**Subject: Rio Algom Mining, LLC; Docket 40-8905  
Response to Request for Additional Information for the  
Closure Plan – Lined Evaporation Ponds at Rio Algom Mining  
LLC's Ambrosia Lake Facility (TAC LU0070)**

**RIO ALGOM MINING COMPANY'S RESPONSE TO REQUEST FOR  
ADDITIONAL INFORMATION FOR THE CLOSURE PLAN -LINED  
EVAPORATION PONDS AT RIO ALGOM MINING LLC'S AMBROSIA LAKE  
FACILITY (TAC LU0070)**

RAI Figure 3. Gamma Radiation Survey Results

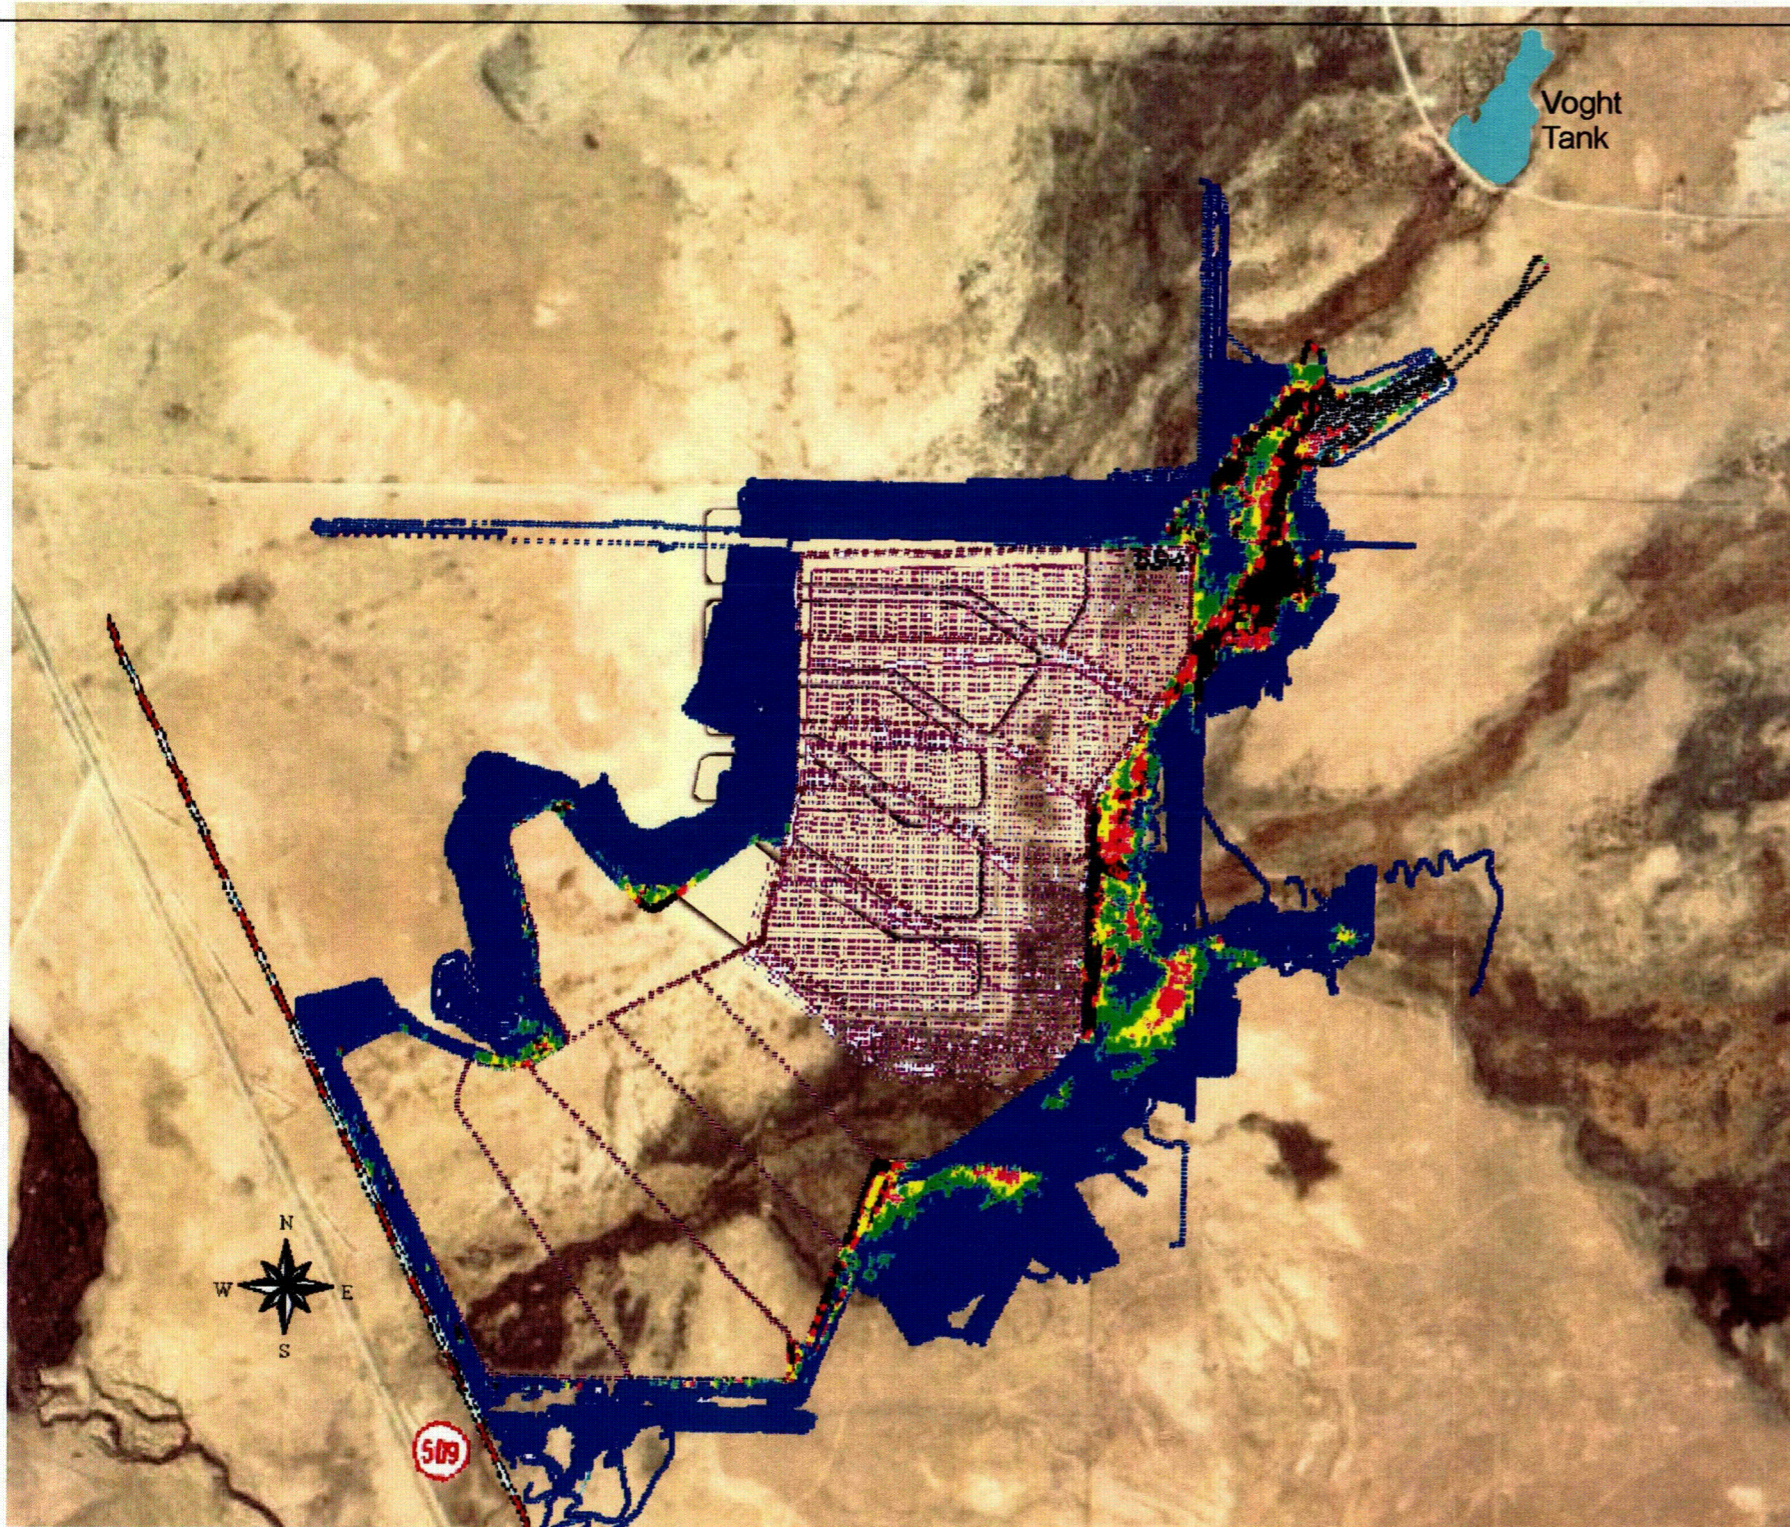
***Request: Provide a map of the gamma survey results with individual color points visible and an explanation of the gamma range represented by each color. Also, describe the Voght tank.***

Gamma radiation surveys performed as part of the DOE UMTRA surface reclamation at the former UNC (Phillips) Mill, identified elevated radiation levels within the drainages into and out of Voght Tank. DOE included these drainages, down to and including Voght Tank sediments, within the site cleanup plan; but the dam and drainages downstream from Voght Tank were not included in the DOE site cleanup plan.

Rio Algom performed preliminary characterization surveys to support the visual evidence of impacts attributable to the mine dewatering activities that flowed to and through the Section 4 area prior to pond construction. Presentation of this information (Figure Gamma map #) is intended to support this contention.

Figure 2-3. Mine Discharge Channels (Blue Arrows)

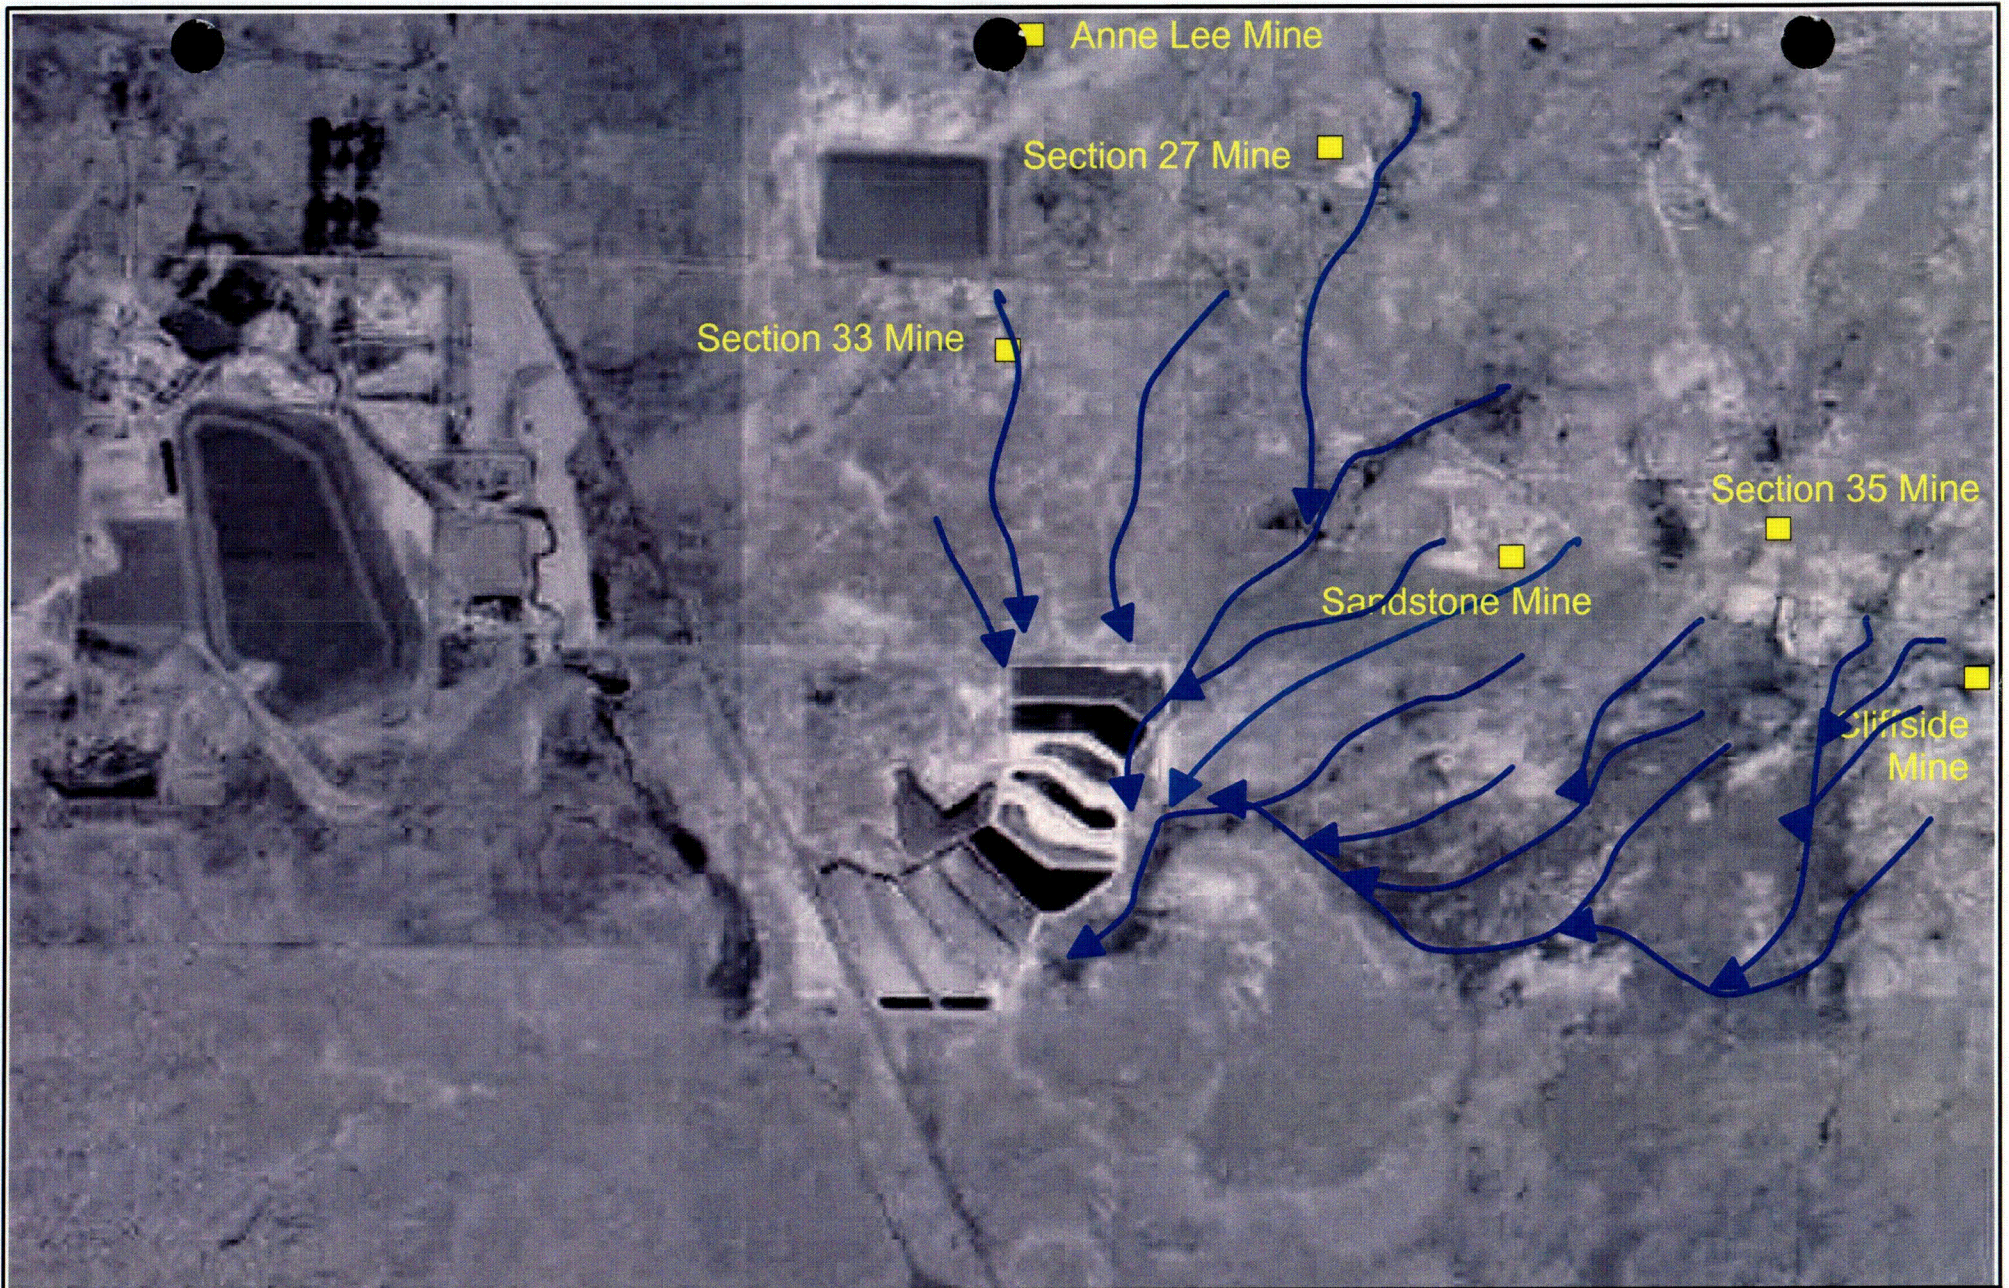
***Request: Provide any State map or other source to substantiate the location and use of these specific drainage channels for mine drainage.***

A document prepared by the New Mexico Health and Environment Department (NMHED) (currently New Mexico Environment Department) titled "Water Quality Data for Discharges From Uranium Mines and Mills in New Mexico" (Goad, et al, 1980) lists water production from New Mexico uranium mines that were active in November 1979. Sixteen of the active mines were in the Ambrosia Lake Valley. Six of these (mines in Sections 27, 28, 33, 34, 35, and 36), are located entirely or partly in drainage systems that flow through the Section 4 Pond area, as illustrated in Figures 1 and 2 (compare to Figure 2-3 of the Closure Plan). Rio Algom would like to note the following errors/omissions on Figure 2-3 of the Rio Algom's October 2004 Closure Plan:
